TRANSMITTAL OF RESPONSES TO THE U.S. ENVIRONMENTAL PROTECTION AGENCY COMMENTS AND THE REVISED INTEGRATED REMEDIAL DESIGN PACKAGE FOR AREA 2, PHASE III PART TWO

**RESPONSES TO U.S. ENVIRONMENTAL PROTECTION AGENCY
TECHNICAL REVIEW COMMENTS ON THE
DRAFT IMPLEMENTATION PLAN FOR AREA 2, PHASE III PART TWO
(20460-PL-0001, REVISION B)**

WP / WO NO.: 20402	S/C NO.: FSC 614	Pg 1 OF 1	DATE 2/8/00
S/C TITLE: SOUTHERN WASTE UNITS - EXCAVATION			RCI NO.: N/A
RESPONSIBLE DISCIPLINE: E <input type="checkbox"/> M <input type="checkbox"/> C X <input type="checkbox"/> OTHER <input type="checkbox"/>	RCI/DCN TITLE: Revised Radium Excavation	DCN NO.: 20402-102

AREA 2 PHASE III PART 2

TRAFFIC PLAN
 DCN 20402-102
 DCN090396.DGN
 SKETCH 1 OF 2
 SCALE 1"=600'

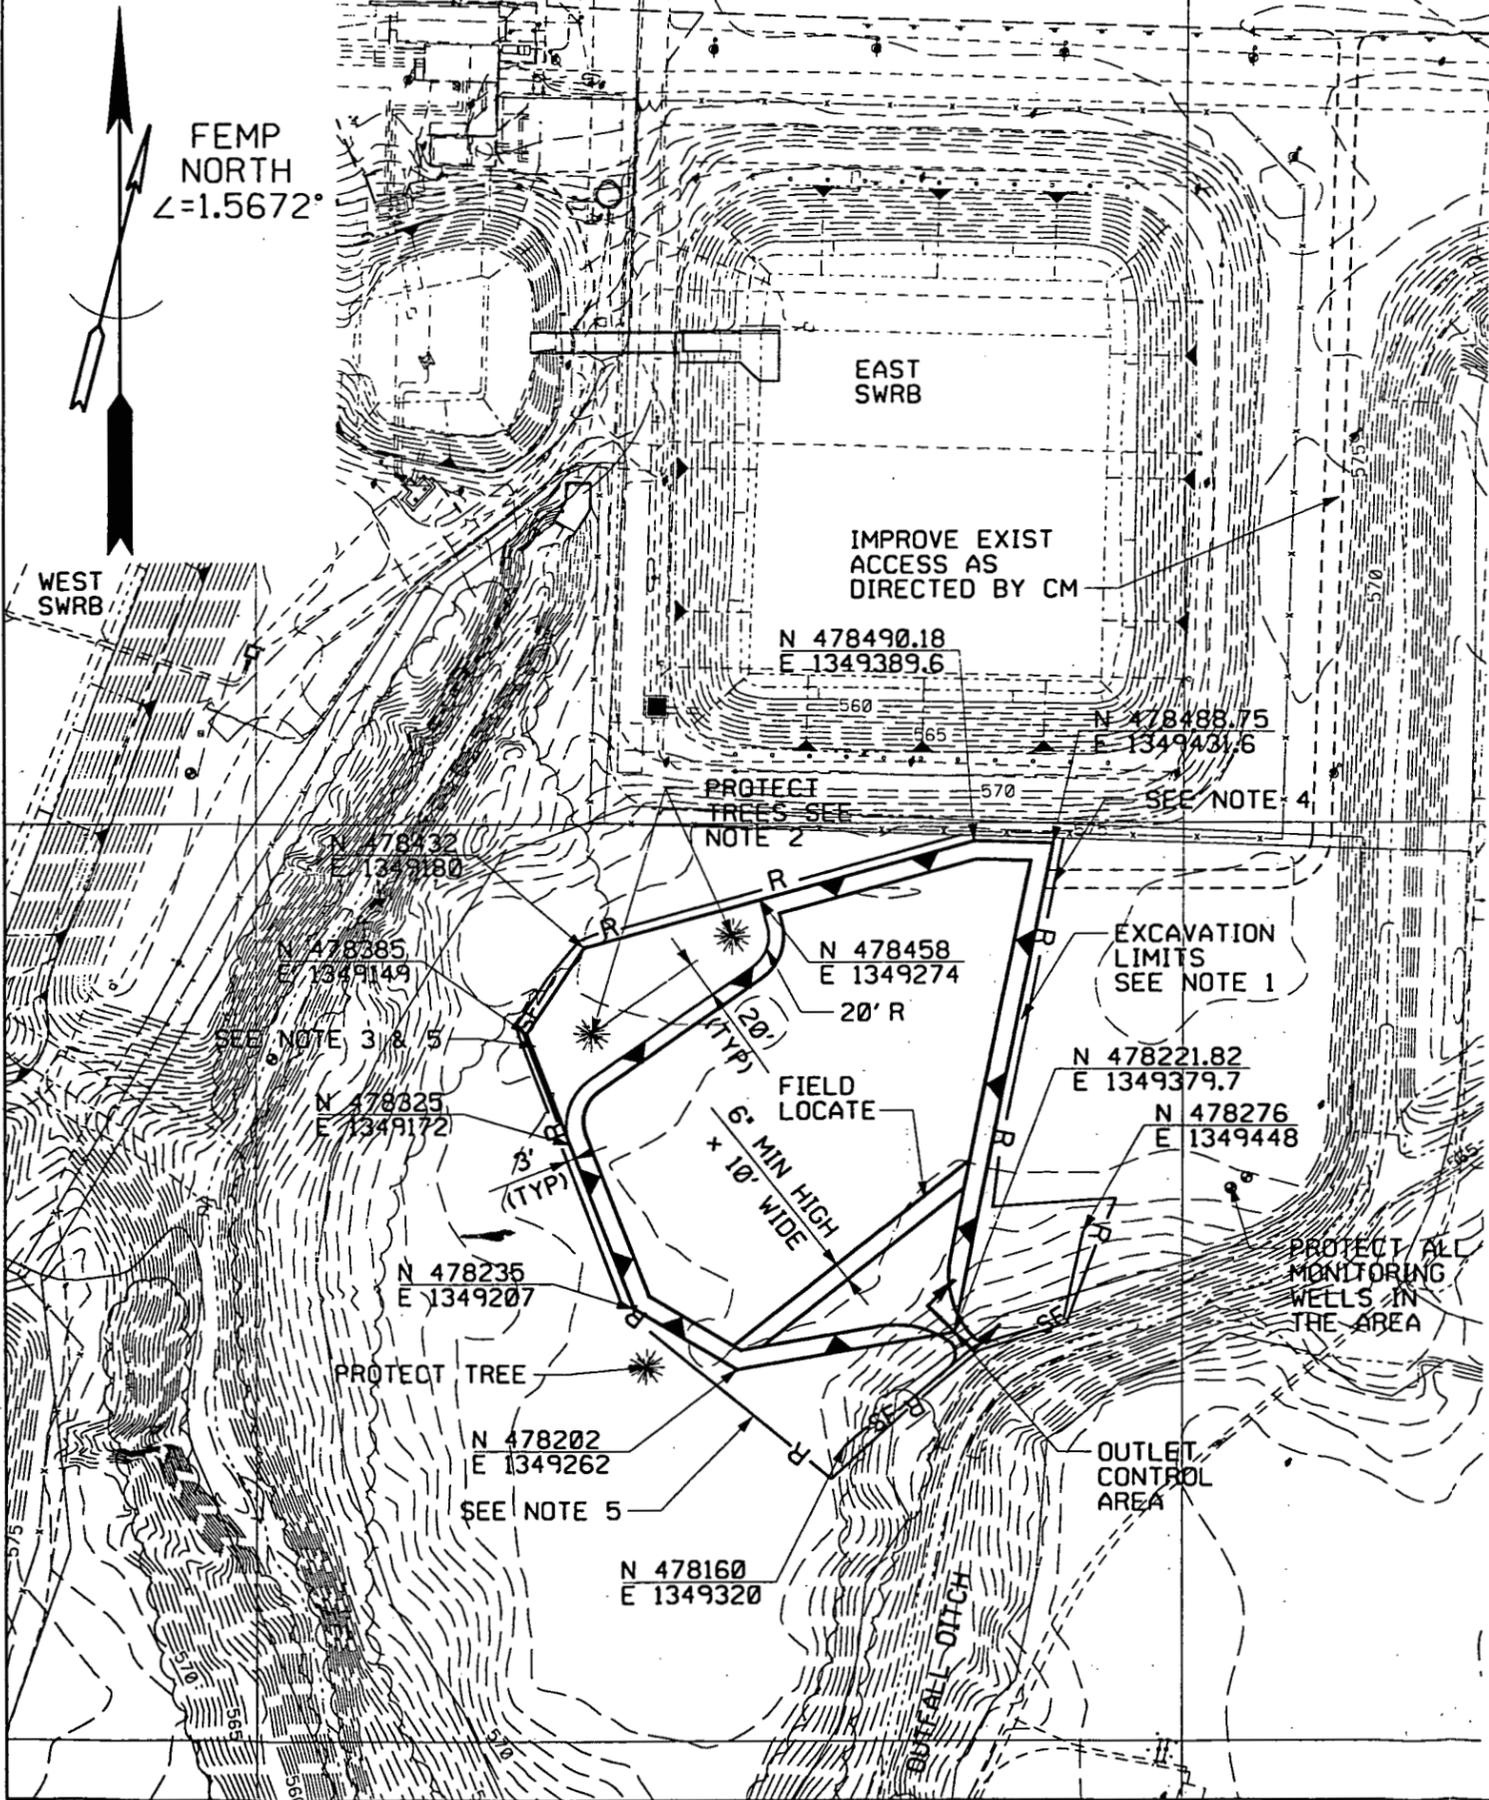
This DCN brings into the scope of the contractor's work the excavation of the Area 2, Phase III radium area, which consists a 3 foot excavation for a volume of approximately 5080 yd³. The attached sketches show the excavation footprint and the traffic route for the haul vehicles to follow, and will be incorporated into the design package as drawings with the next package update.

- ① TRAFFIC AT OSDF SUBJECT TO OSDF OPERATIONS.
- ② USE SWU EQUIPMENT WASH FACILITY.
